**DOWNTOWN LIGHTING AND PEDESTRIAN IMPROVEMENTS
PROJECT NO. 07-961-83-054**

ADDENDUM NO. 1

May 1, 2008

Sketch 7: Luminaire Pole Base Detail

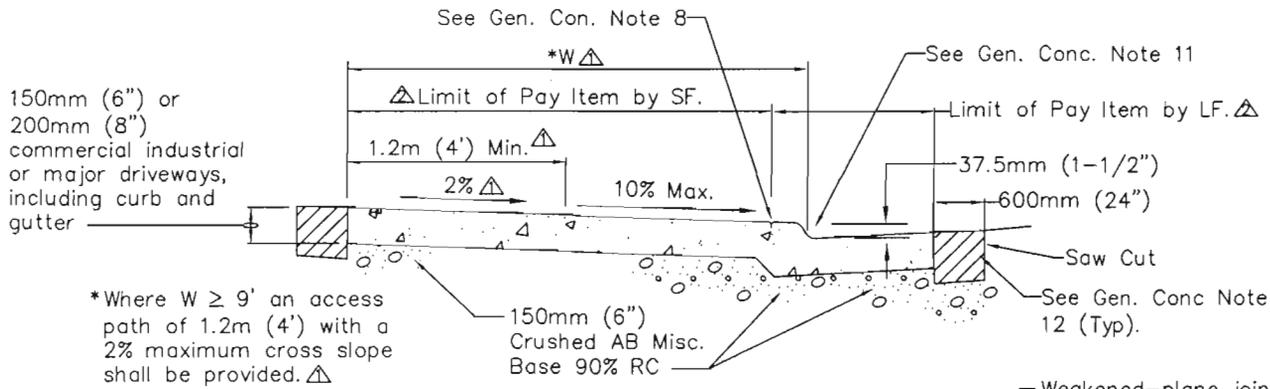
Drawing No. E5.2, Sheet 33

- Revise footing detail 3/E5.2 per attached drawing in (Sketch 7 in Attachment C). Footing is now 30" diameter with deeper embedment.

CONCRETE DRIVEWAY APPROACH

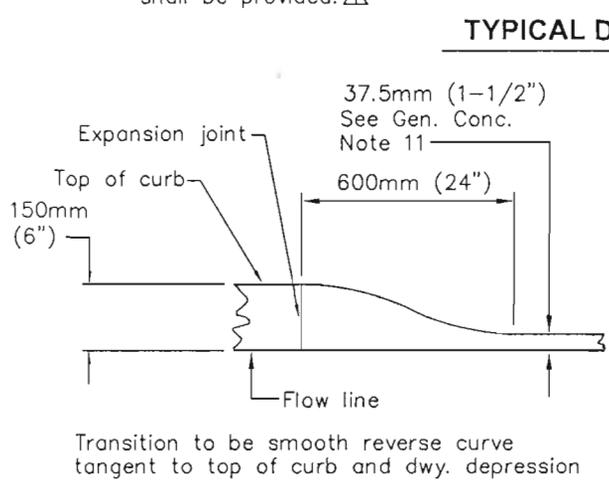
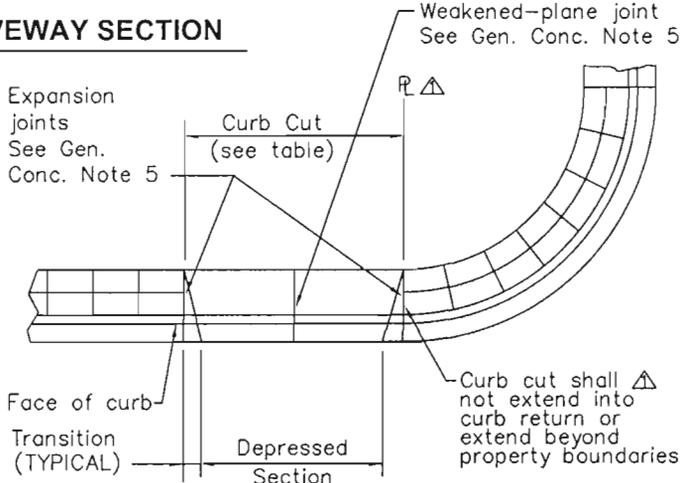
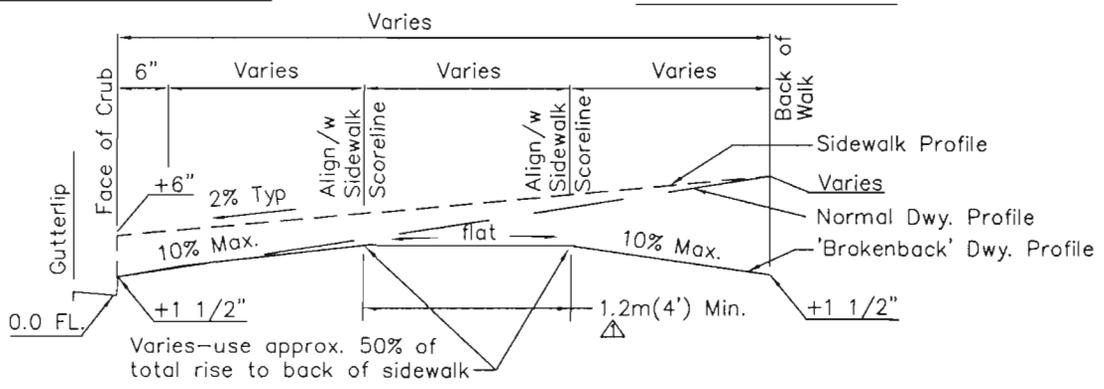
Drawing G6, Sheet City Standard Details:

- Add City Standard Details 102 - Concrete Driveway, and 608 –Traffic Control Plan Guidelines. (See Sketches 1 through 4 in Attachment C).

APPENDIX 1 - SKETCH 5

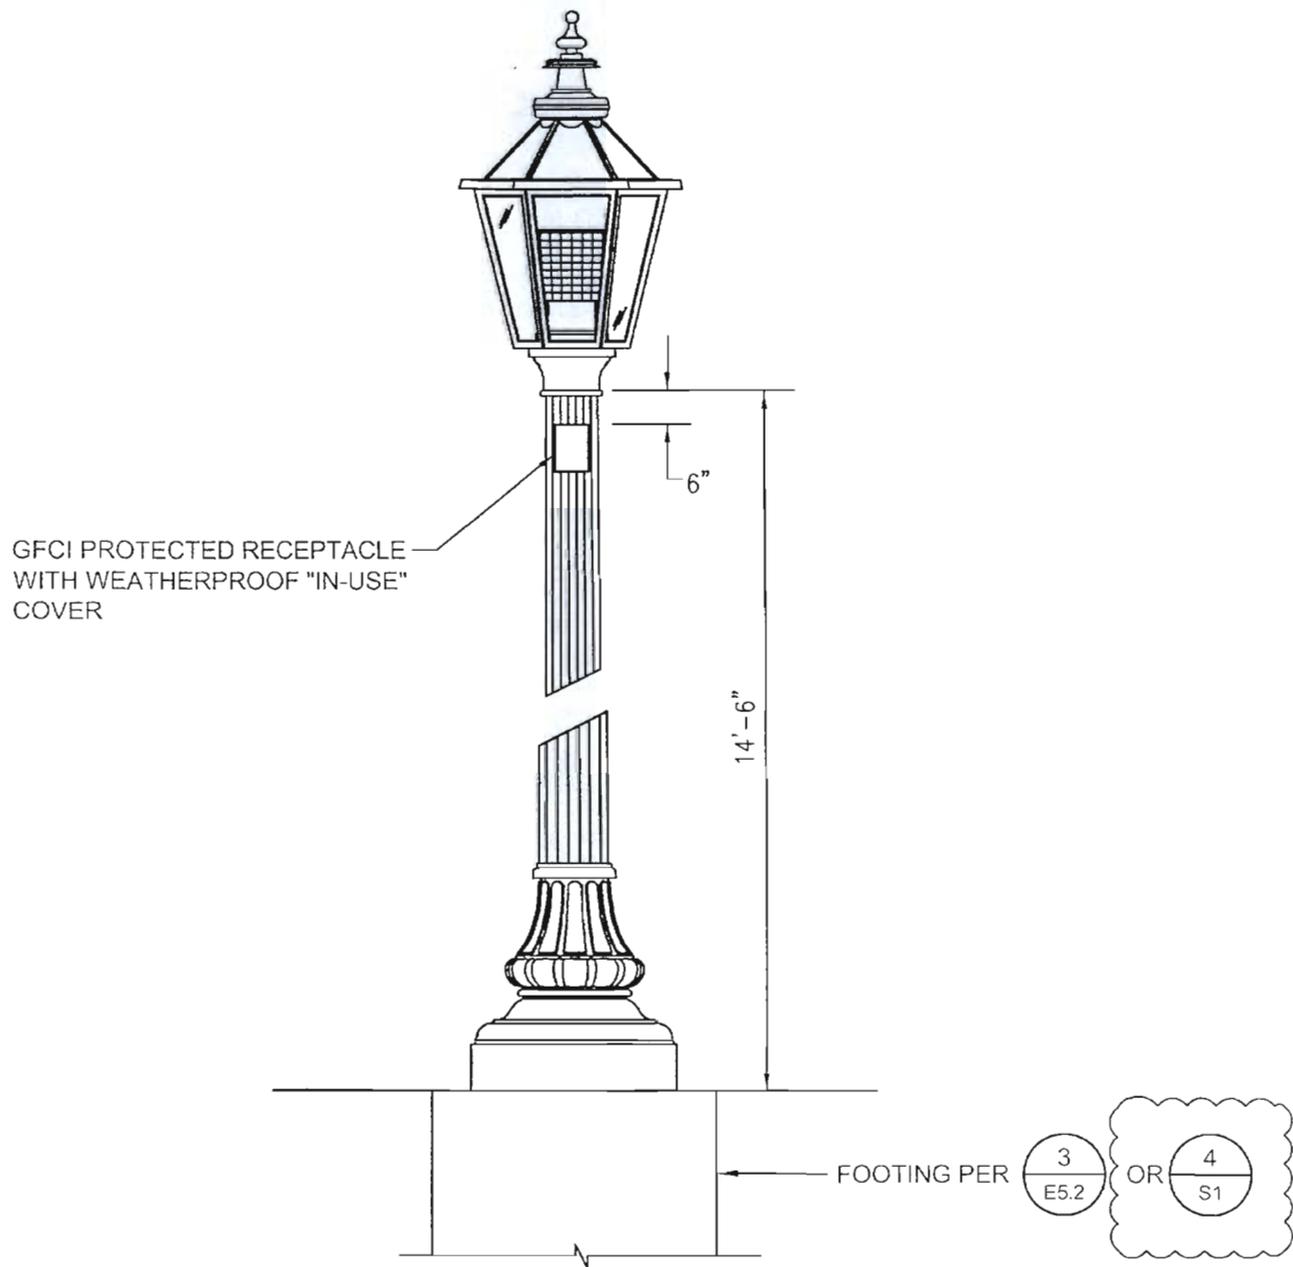
Drawing No. E0.2, Sheet 23.

- Replace the Panel Wiring Schedule for the Downtown Panelboard with the attached Panel Wiring Schedule for the Downtown Panelboard (Sketch 5 in Attachment C).

DT POST-TOP PEDESTRIAN LIGHT
NTS

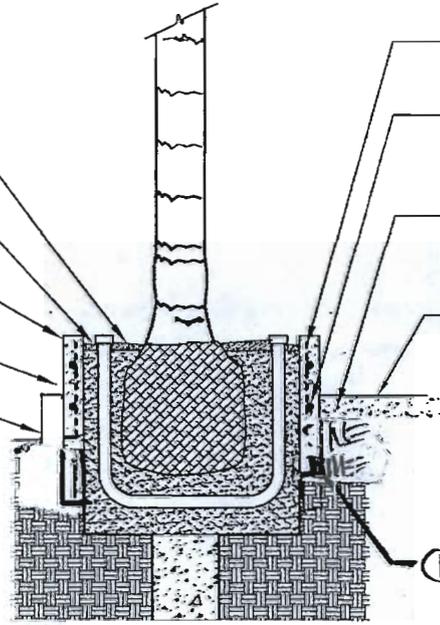
Drawing No. E5.1, Sheet 32

- Detail DT -Add footing detail callout per attached drawing in (Sketch 6 in Attachment C)

CONCRETE RAISED 6' X 8' PLANTER
TO BE INSTALLED AT FIVE PALM TREES

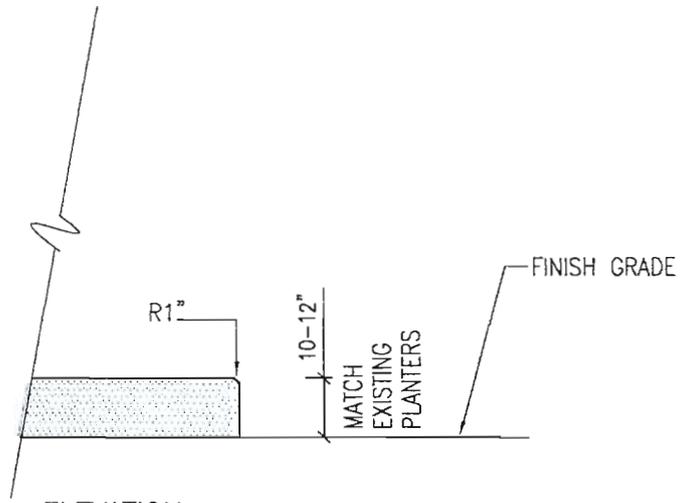
Drawing No. LD-7, Sheet 47.

- Revise Bollard Detail C as follows: change bollard brand note from the 'Cadbury International' to "HADCO TRADITIONAL BOLLARD WITH STANDARD BLACK FINISH (MODEL EU30 N A)", install per manufacturer requirements.
- Add new detail, "CONCRETE RAISED 6'x8' PLANTER TO BE INSTALLED AT FIVE PALM TREES" per attached drawing. (*Sketch 8 – in Attachment C*)
